Access Compliance Report

Public Rights-of-Way

(Curb Ramps)

Intersection ID: 47453	Main Street: WOOD_DUCK_CROSSING_DR	Cross Street: WHISTLING_SWAN_RD	Location: NE
ADA ID: 0B53067012F7	Ramp Type: BlendTrans2	Initial Pass/Fail: Fail	Overall Compliance: No
Severity Score: 8.75			
Codes/Mitigation Info/Possible Solution		Field Measurements/Component Compliance

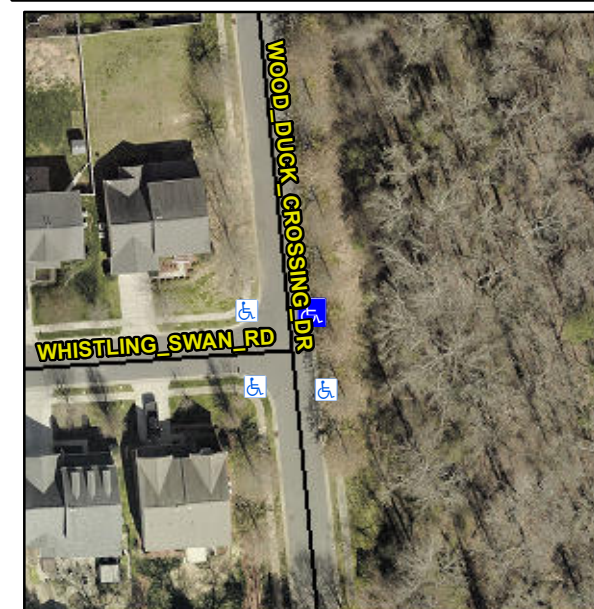
Not Found, R304.5.1

Compliance	Description	Data	Compliance	Description	Data
N/A	Ramp Length (in)	95.0	Yes	BlendTrans Slope (%)	1.0
No	Ramp Width (in)	38.0	Yes	BlendTrans XSlope (%)	0.1
N/A	Flare Type LT	N/A	N/A	Flare Type RT	N/A
N/A	Flare Slope LT (%)	N/A	N/A	Flare Slope RT (%)	N/A
N/A	Flare Traversable LT?	N/A	N/A	Flare Traversable RT?	N/A
N/A	Landing Length (in)	N/A	N/A	DWS Provided?	N/A
N/A	Landing Width (in)	N/A	N/A	DWS Contrast?	N/A
N/A	Landing Slope (%)	N/A	N/A	DWS Length (in)	N/A
N/A	Landing X Slope (%)	N/A	N/A	DWS Full Width?	N/A
N/A	Landing Curb? (Y/N)	N/A	N/A	DWS Offset (in)	N/A
N/A	Shared Landing?	N/A			
N/A	Gutter Ponding?	N/A	N/A	Gutter Slope (%)	N/A
N/A	Gutter Lip Ht (in)	N/A	N/A	Gutter X Slope (%)	N/A
N/A	Painted X Walk1?	No	N/A	Painted X Walk2?	N/A
	X Walk 1 Direction	To W		X Walk 2 Direction	N/A
	X Walk 1 Width (in)	N/A		X Walk 2 Width (in)	N/A
	X Walk 1 Slope (%)	4.1		X Walk 2 Slope (%)	N/A
	X Walk 1 X Slope (%)	0.3		X Walk 2 X Slope (%)	N/A

N/A	Ramp inside XWalk1?	N/A	N/A	Ramp inside XWalk2?	N/A
	Road Slope (%)	0.3		Clear Space?	N/A
	Road X Slope (%)	4.1	N/A	Clear Space to XWalk (in)	N/A
N/A	Any Obstructions?	N/A	N/A	Storm Grate/Utility Hazard?	N/A
	Obstruction Type			Storm Grate/Utility Type	
		N/A			N/A
			Yes	Surface Condition? (G/P)	Good
			No	Curb Slope (%)	11.5

Remove & Replace Curb Ramp With Two New Directional Ramps or Equivalent.
